Service Manual

NISSAN Motor Genuine
2DIN HDD Navigation

Model UQY7793
(N# 25915 ZQ19A)
(MODEL No. NAU-3121KUS-V)

The original model of UQY7793/4/5,UQY7803/4/5 is UQY6102. This additional service manual is designed to be used together with the service manual of UQY6102.

Drawing-30

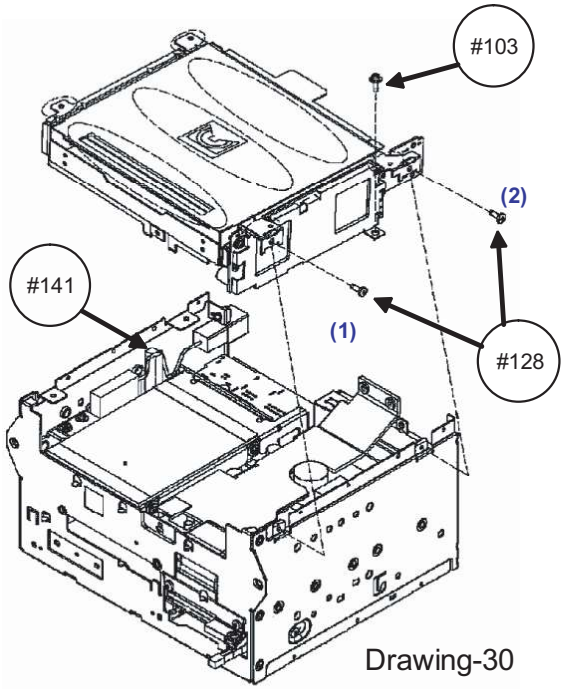
Please confirm it about the additional part (#141) in the following ASSEMBLY DRAWING and ASSEMBLY PROCEDUER.

PROCEDURE	NOTICE
3.Stick the(#141)ANT sheet on the processed AUDIO PWB ASSY (Drawing-30) and lay out GPS-ANT cable.	※Through the SHEET ANT upper part. (Drawing-24)
